TECHNICAL BULLETIN TECH-03-2021

VW 2.0L - 830324-5004S TURBOCHARGER REPLACEMENT

12TH MARCH 2021

Parts to be ordered from franchised VW dealer

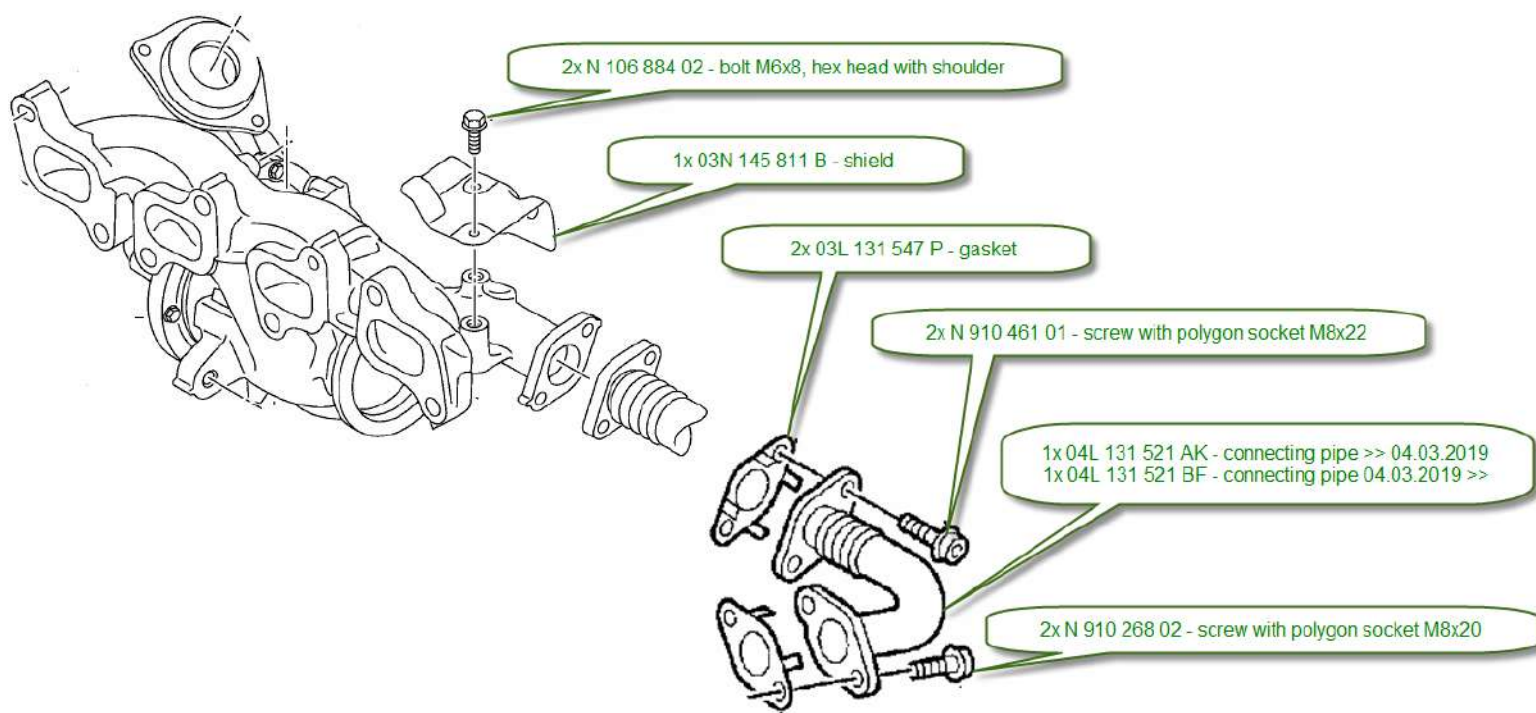
- There is a different position of the flange for EGR pipe on turbine housing – see below

- EGR pipe
- Gaskets
- Heatshield
- Necessary fasteners
